KCK COMMUNITY EDUCATION, HEALTH & WELLNESS CENTER

ADDENDUM #1

PGAV PROJECT #53664-00

April 15, 2024

FLOOR PLAN - DIRT YARD
1/8" = 1'-0" **A1**

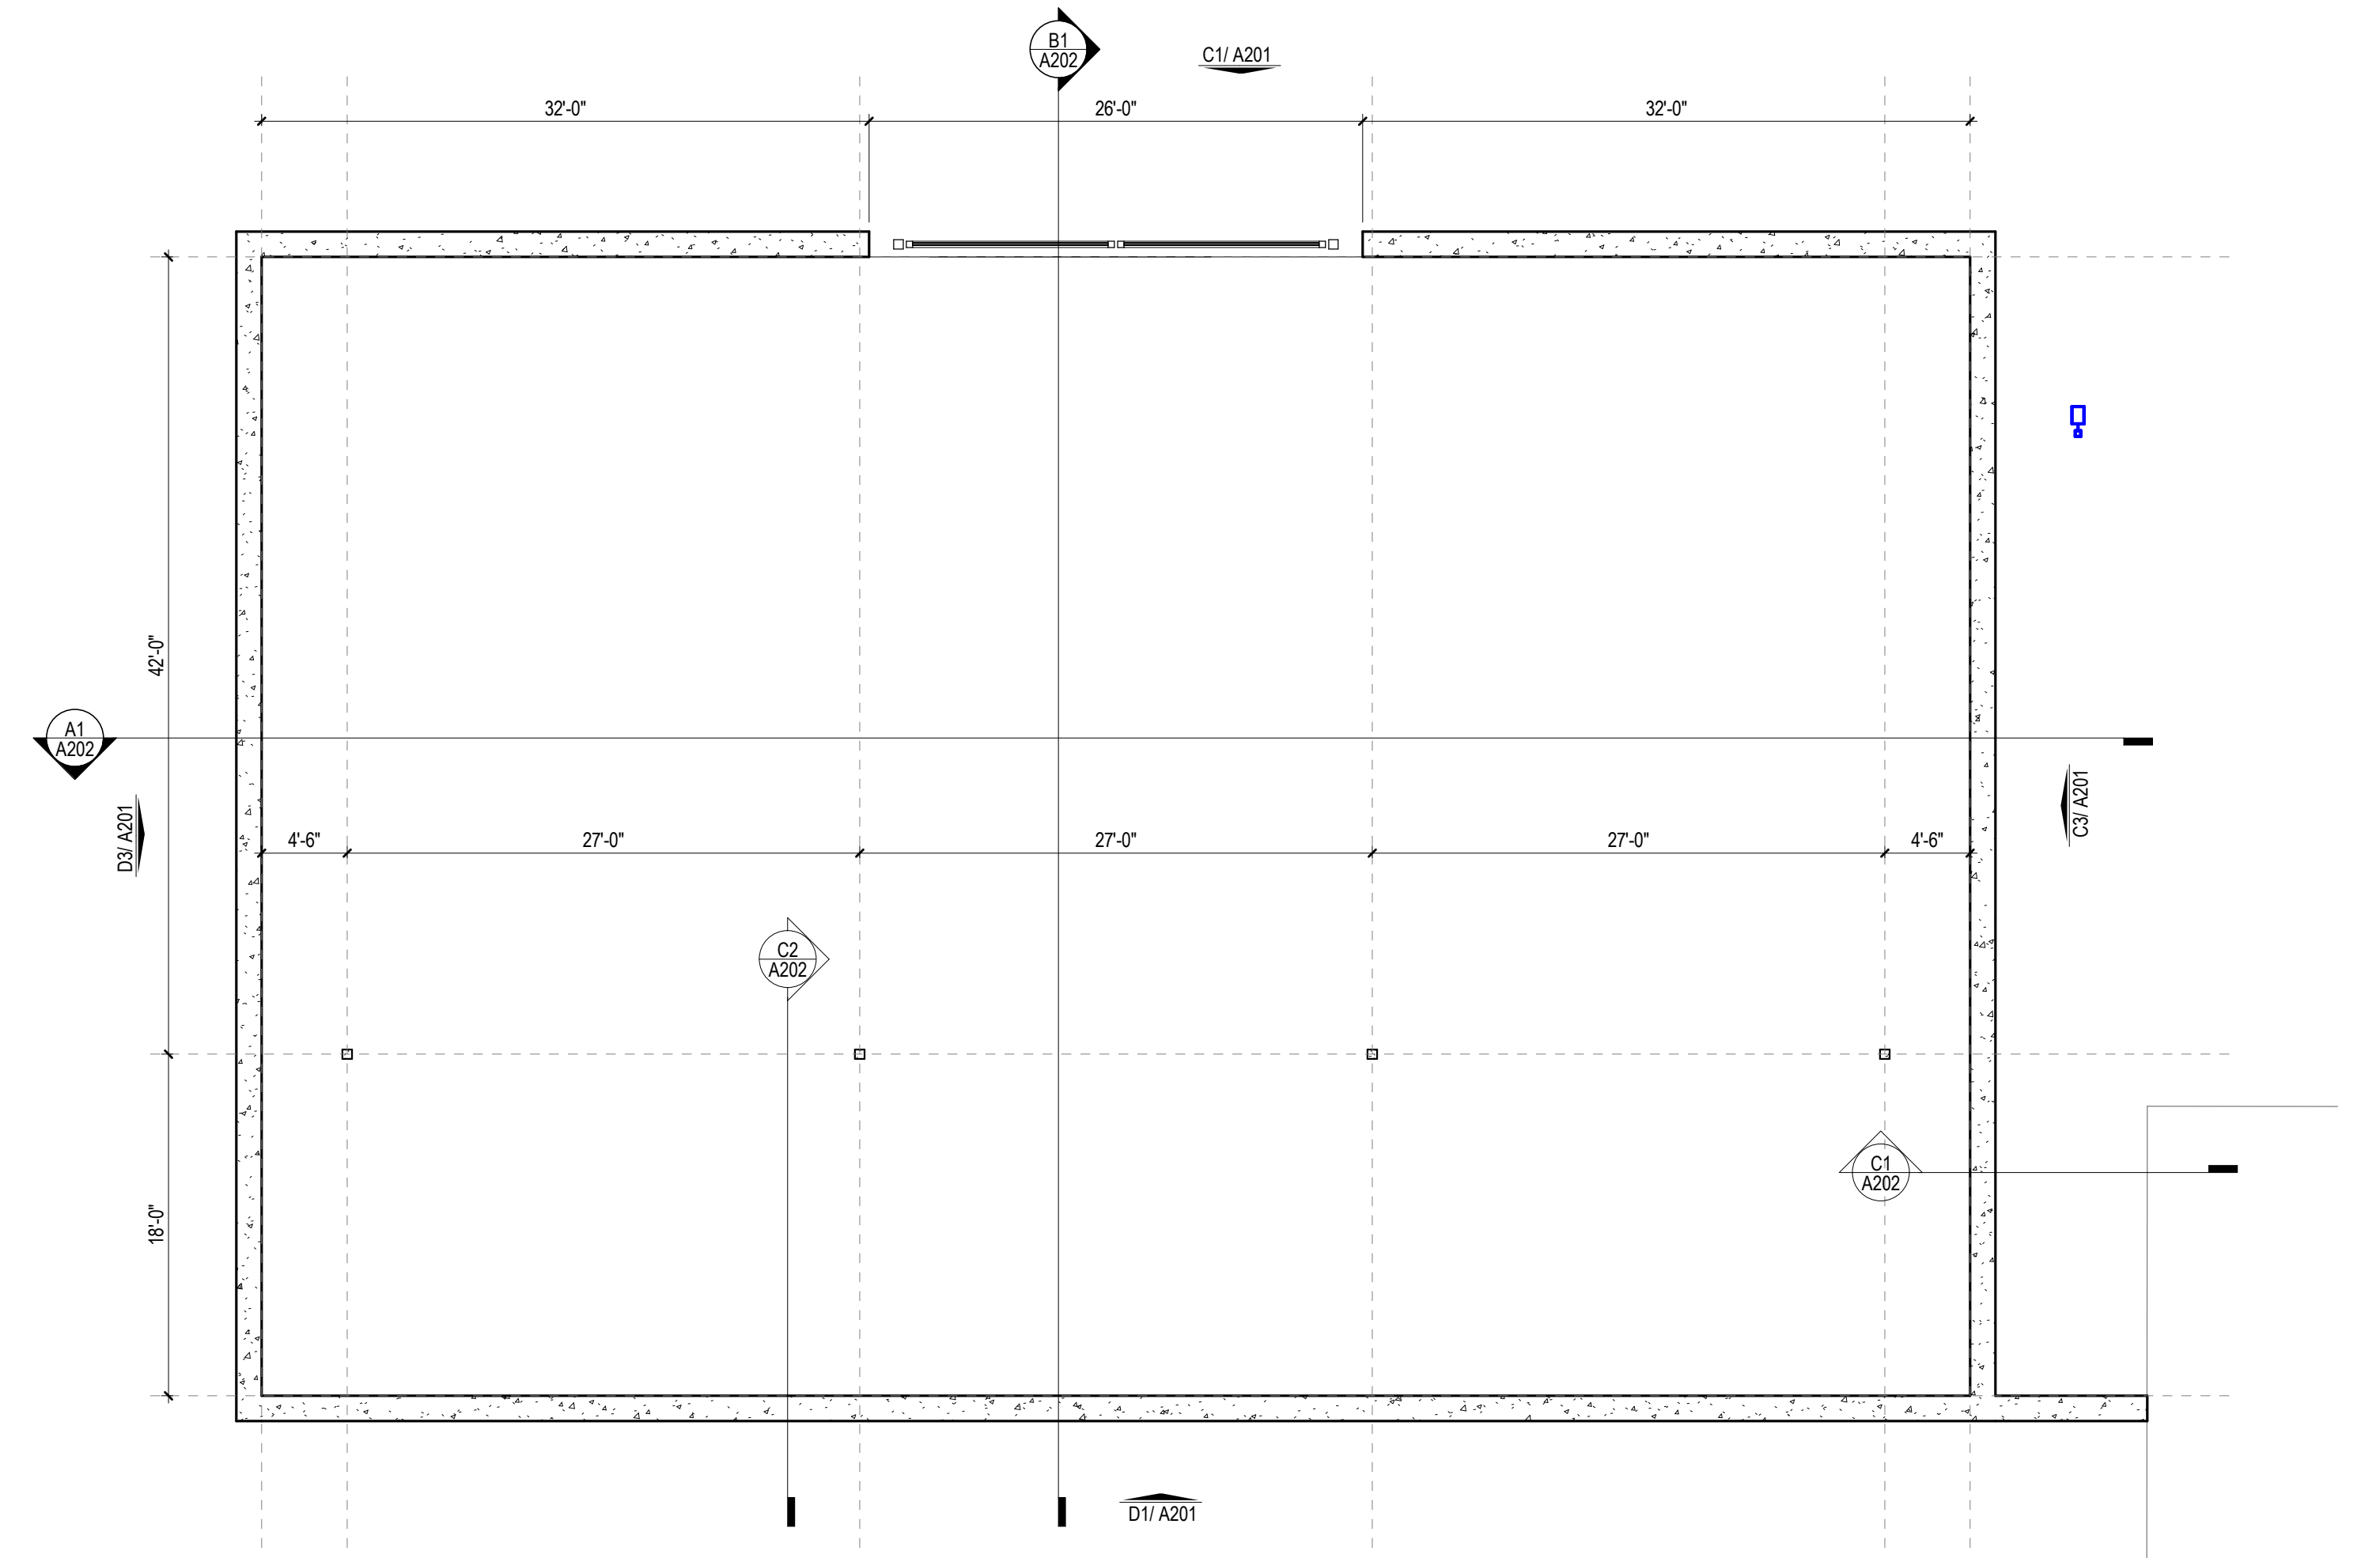
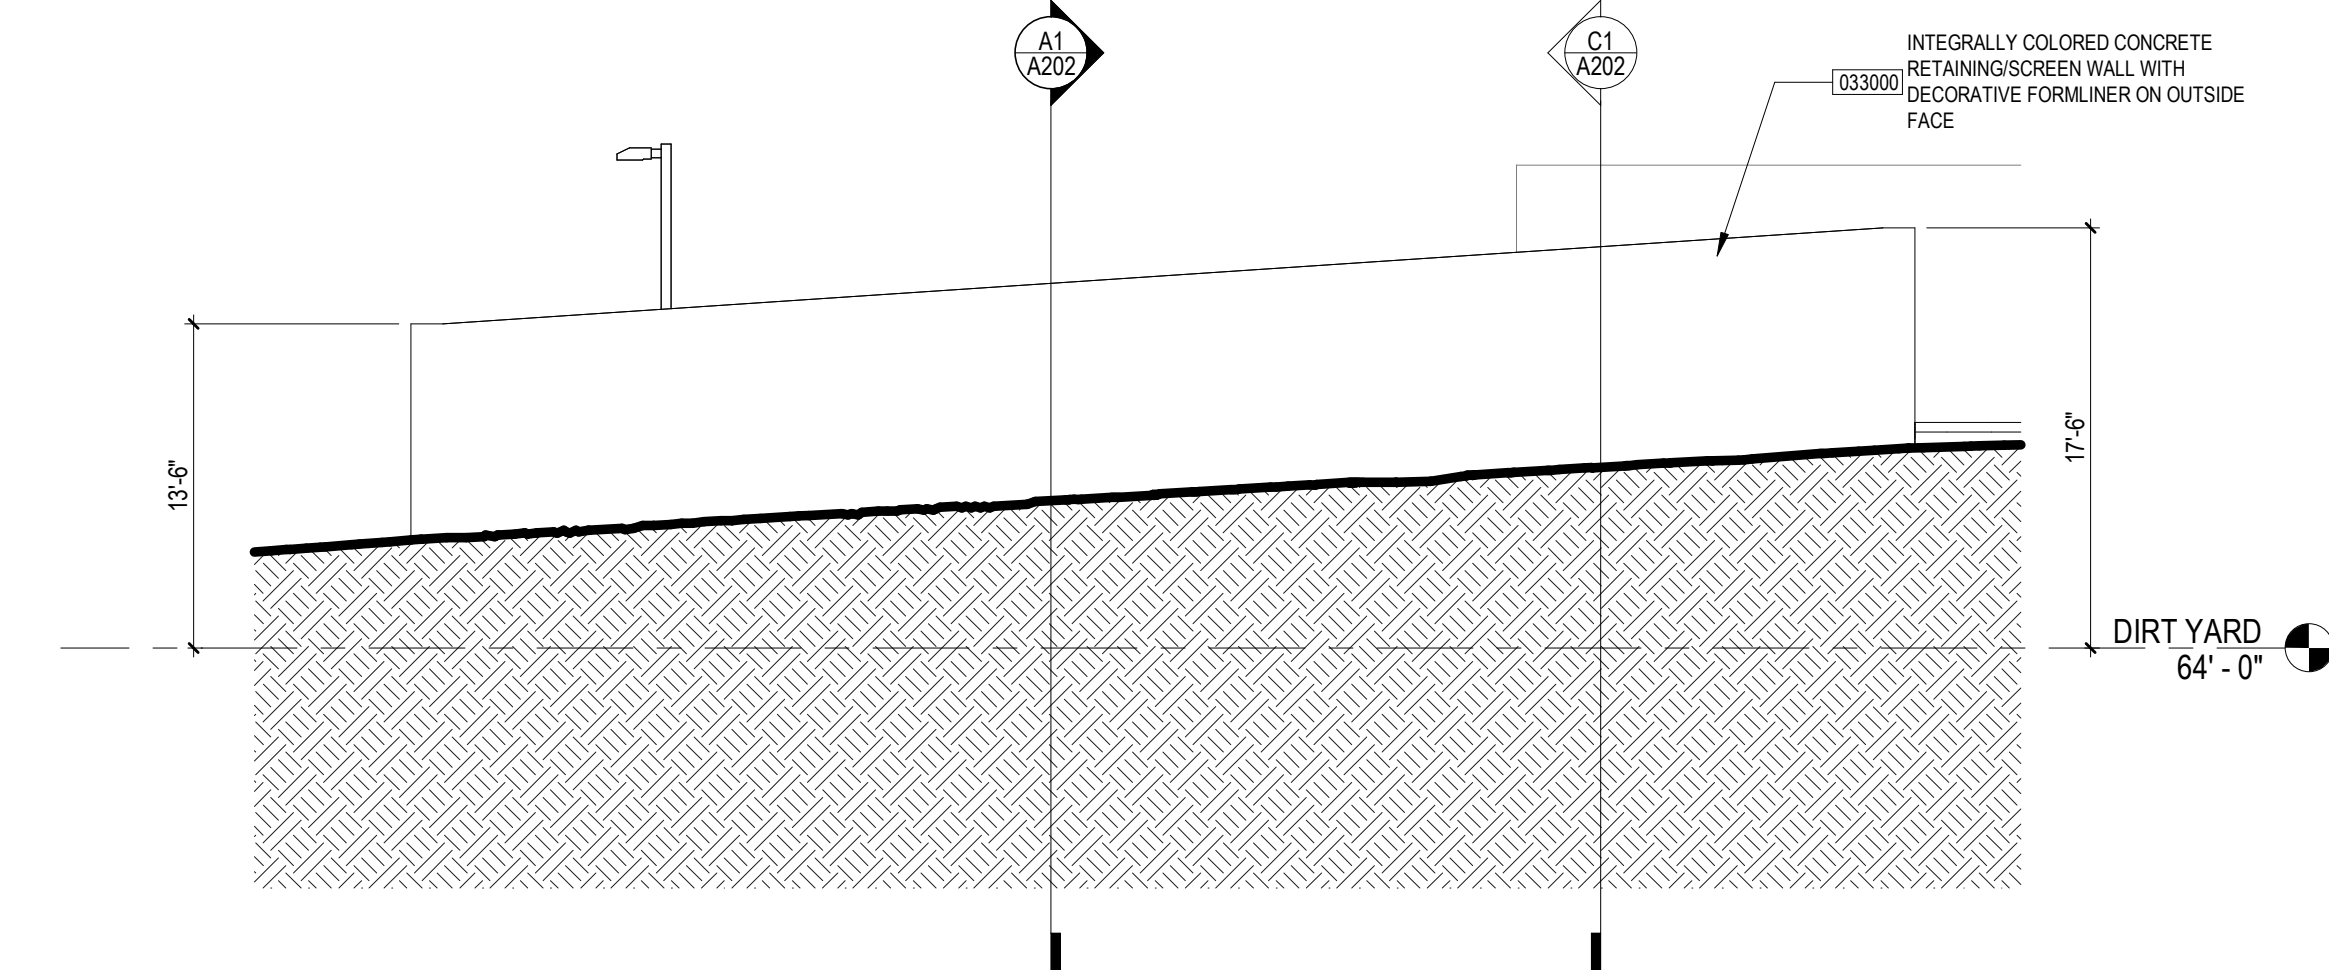
- 3.20 A201 – Site Details – Dirt Yard**
 1. Refer to the attached revised sheet with revisions dated 4/15/2024:
 - a. Clarified wall heights around the dirt yard.

- 23. C402 Retaining Wall Plan and Profile: Dirt Yard retaining wall is not called out and does not provide heights for the surrounding walls, other than on the south side. Please provide additional information and profile similar to other walls so this is not missed.**

ANSWER: Wall heights will be provided in Addendum 1.

SLAB EDGE PLAN - LEVEL 1 - AREA 'A' A1
1/8" = 1'-0"

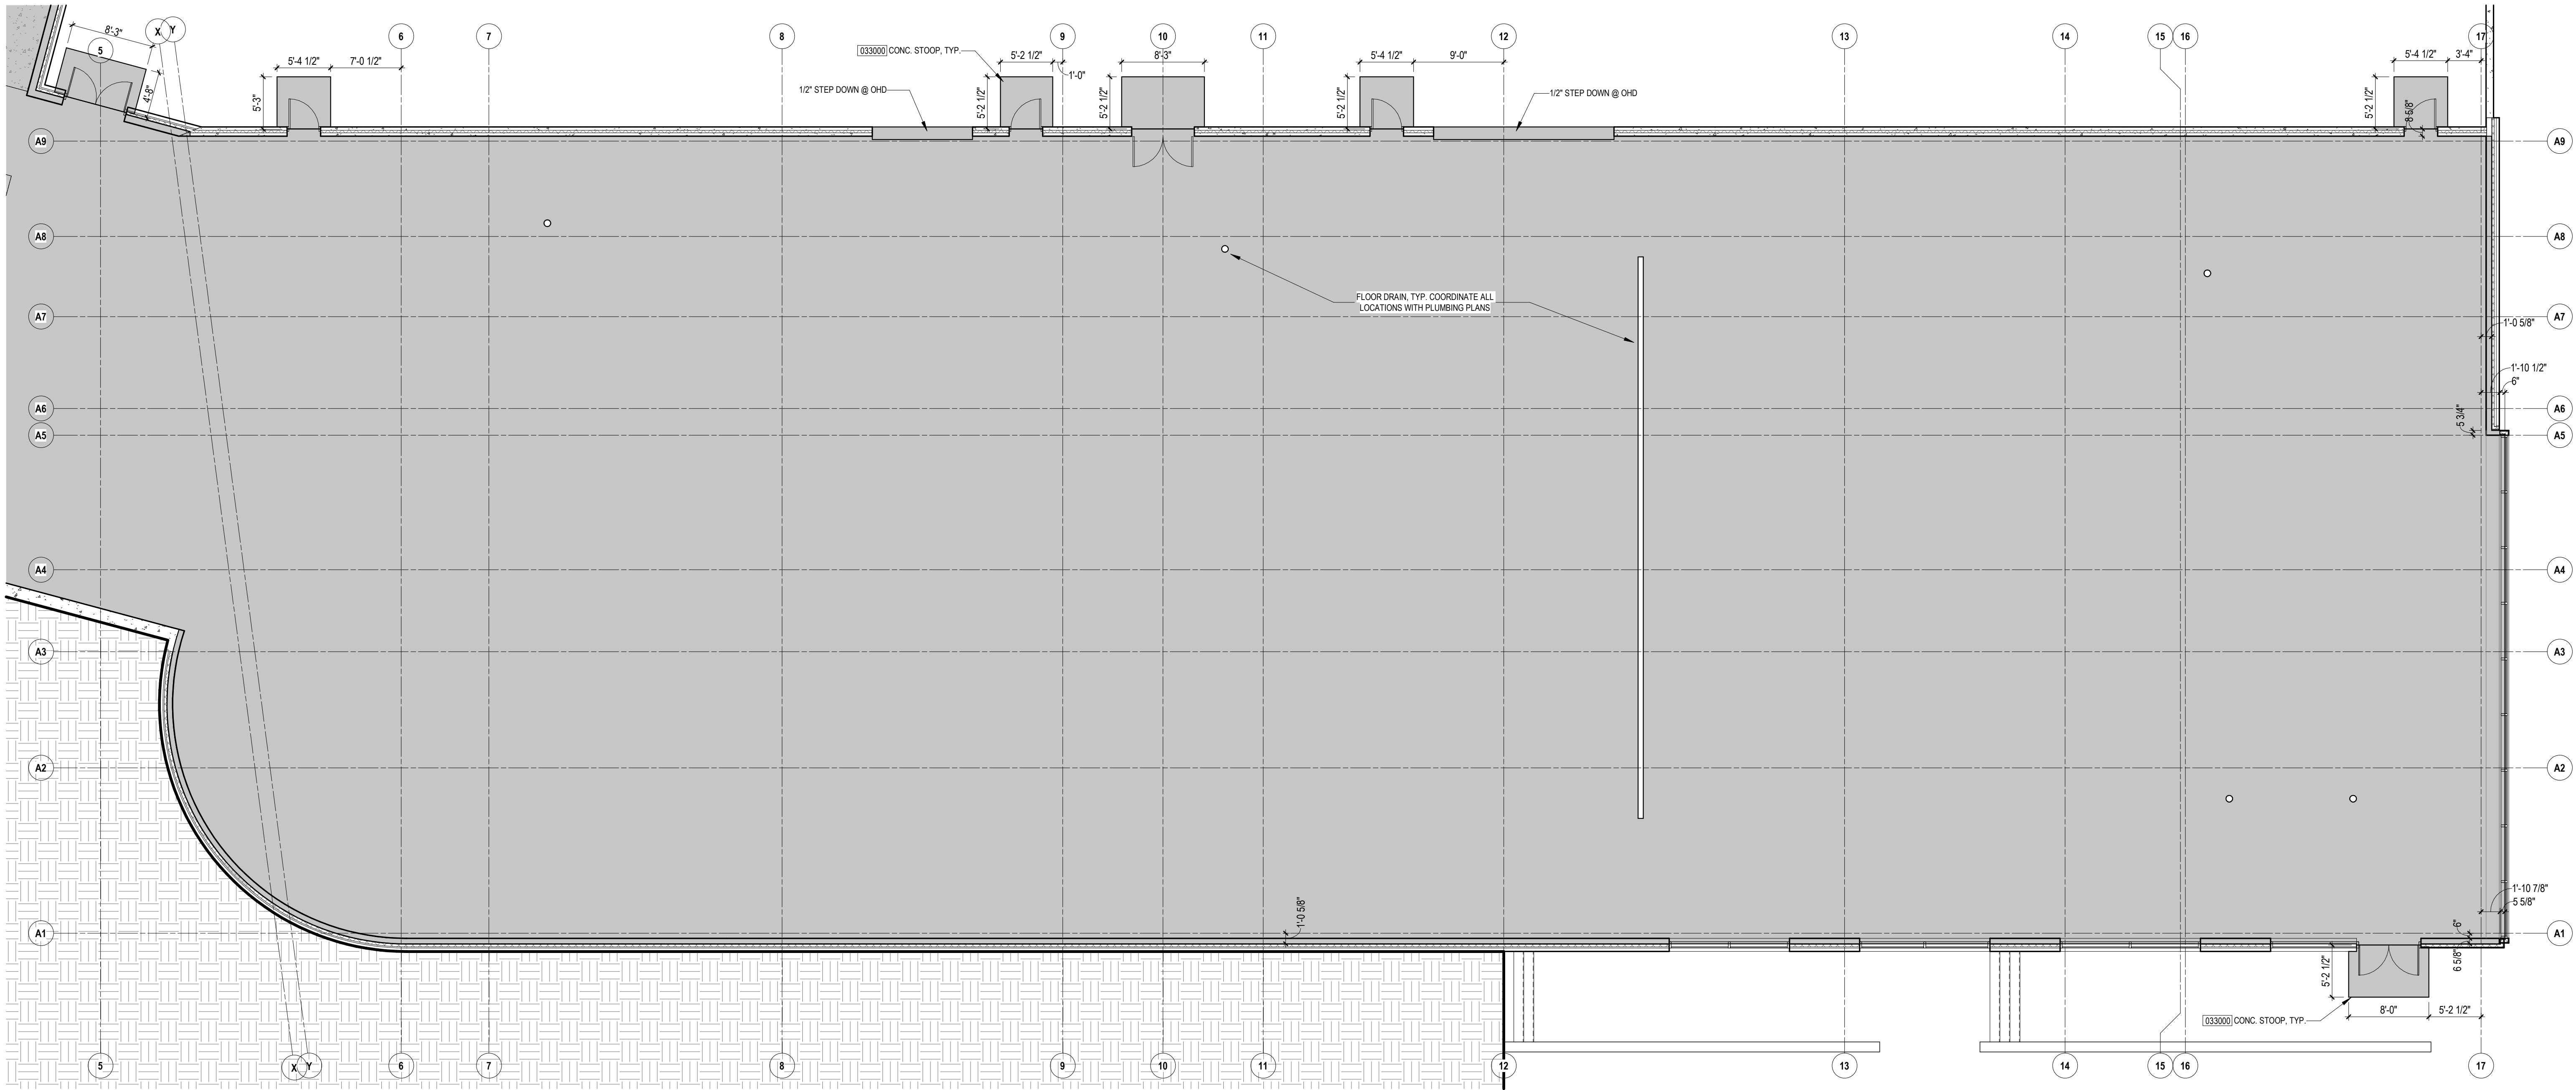
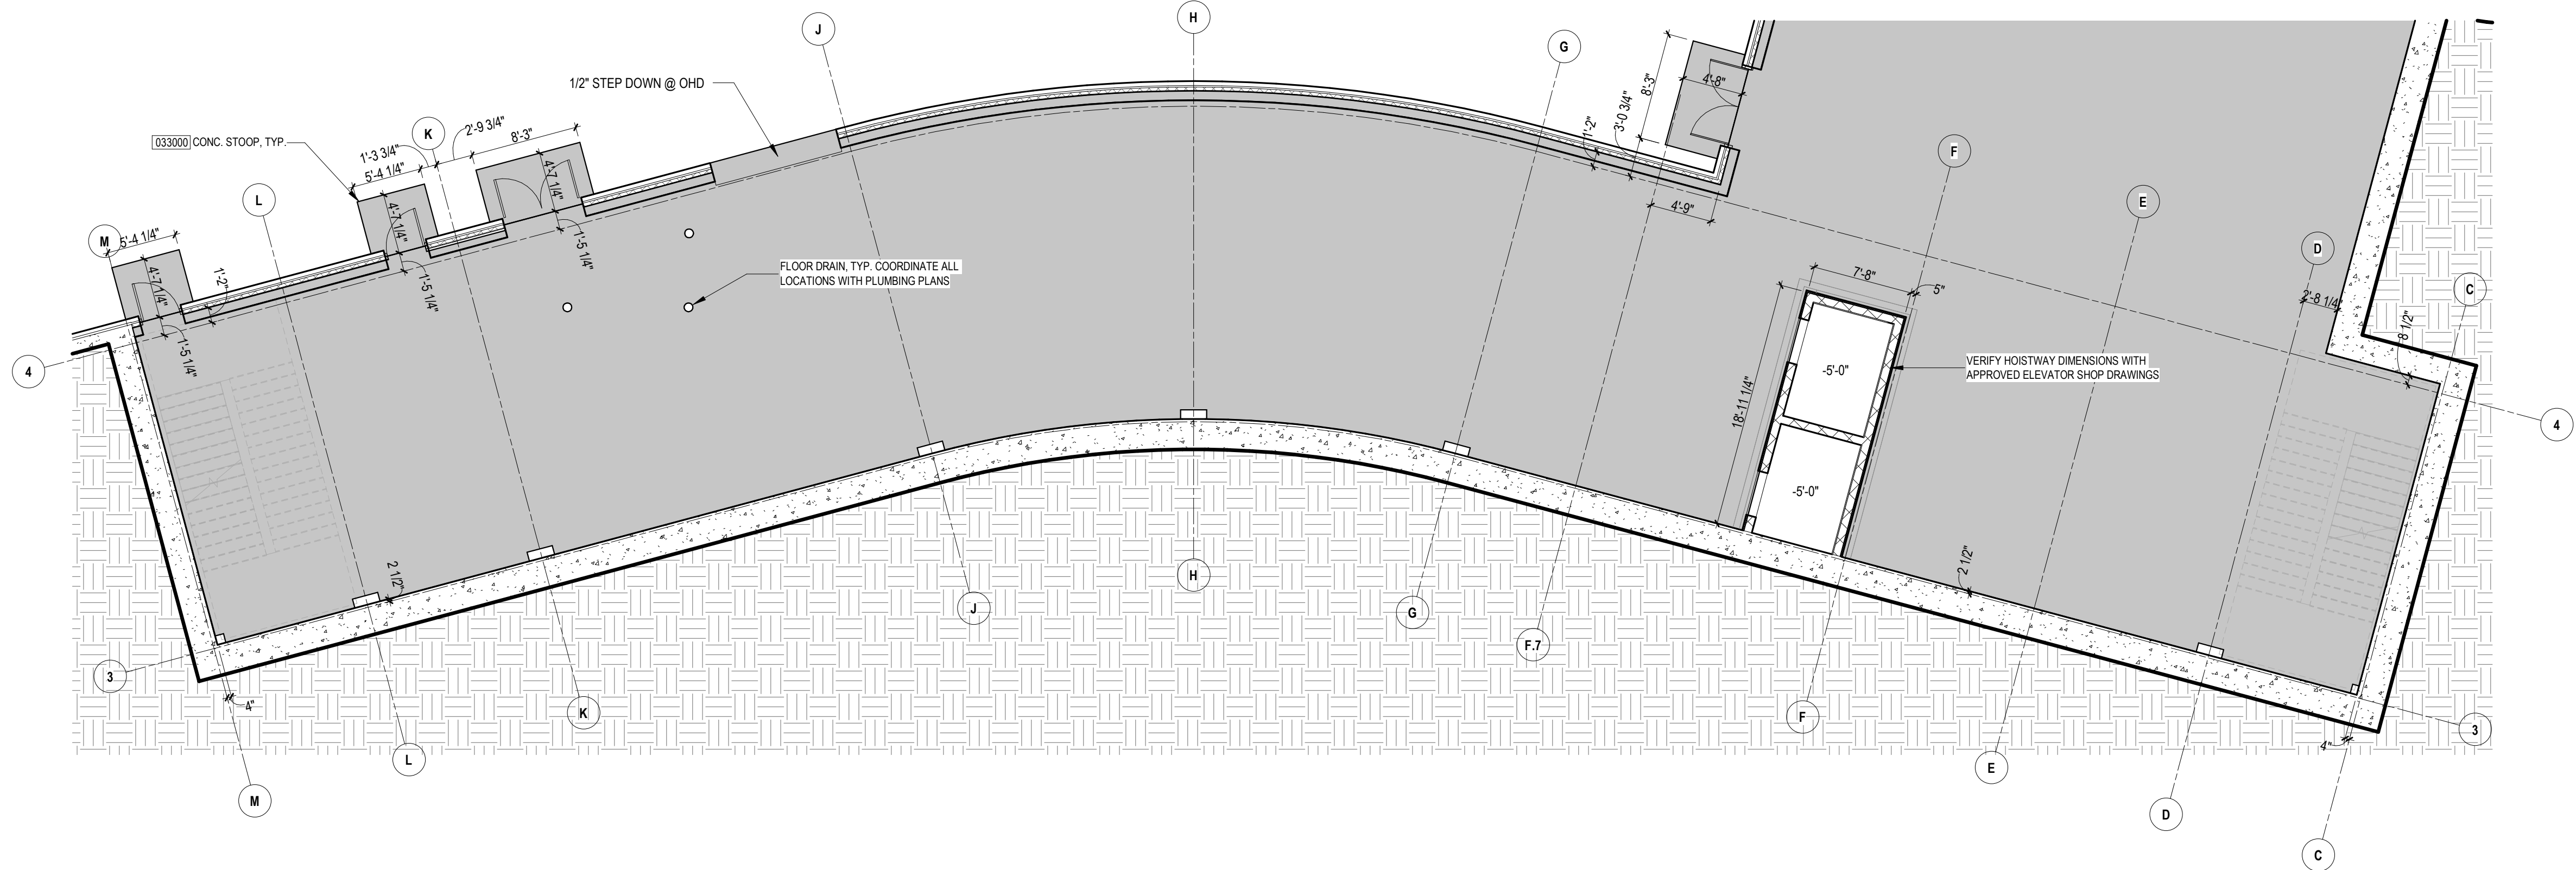
- 3.21 A301 – Slab Edge Plan – Level 1**
 1. Refer to the attached revised sheet with revisions dated 4/15/2024:
 - a. Clarified edge of slab locations.
- 3.22 A302 – Slab Edge Plan – Level 2**
